Ducted Systems Technical Services: Service Tips Letter

Letter: ST-022-22

Subject: **Simplicity Controller Solder Trace Failures**

Product/s: **Light Commercial Simplicity Controllers (Lite and 1A Controllers Only)**

Material: S1-02421678700 Description: RELAY, CNTRL,24V,50/60 HZ, SPST

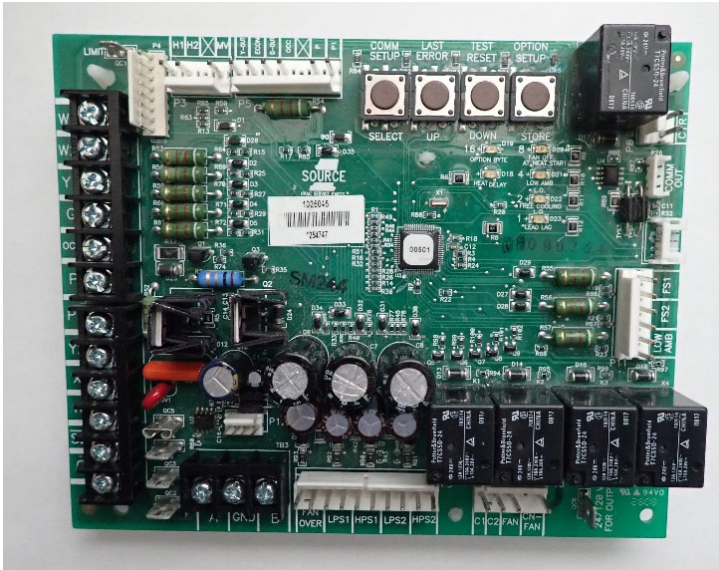
If a controller solder trace has failed from the W1 or W2 thermostat input to their H1 or H2 output, certified HVAC Technicians are authorized to bypass the controller and utilize a field-supplied single-pole single-throw relay. This type of failure must be verified using an ohm meter between W1 to H1, or W2 to H2 terminals with wires and harnesses disconnected (the meter should read an open circuit). Once verified the circuit is open, the resolution below is authorized **only for temporary use in the heating mode.**

To install the relay, certified HVAC Technicians will need to field supply wire for the thermostat's W1 wire termination, H1 wire, and tap into the 24v output terminal of the equipment's factory-installed stepdown transformer. **(All voltages should be confirmed with a voltage meter before wiring to ensure only low voltage is being used).** In addition, standard industry safe electrical work practices must be followed, and the system should be de-energized with appropriate Lockout-Tagout precautions at the power source.

To wire the relay, certified HVAC technicians should field wire splice into the 24v of the transformer and splice into the H1 or H2 output wire, and attach them to the contacts of the relay. Then an additional field-installed wire should be spliced into the board's W1 or W2 and the transformer's grounded common wire of the secondary side. These wires will be attached onto the coil of the relay to allow operation of the heating mode. (The same process can be used for W2 to H2 solder trace failures) **Note: During this process, the thermostat should be sending the W1 or W2 signal to the thermostat terminal on the simplicity controller and the relay at the same time to ensure fan operation.**

Field Wiring Specifications: 18 AWG stranded wire, minimum thermal rating of 105°C, rated VW-1.
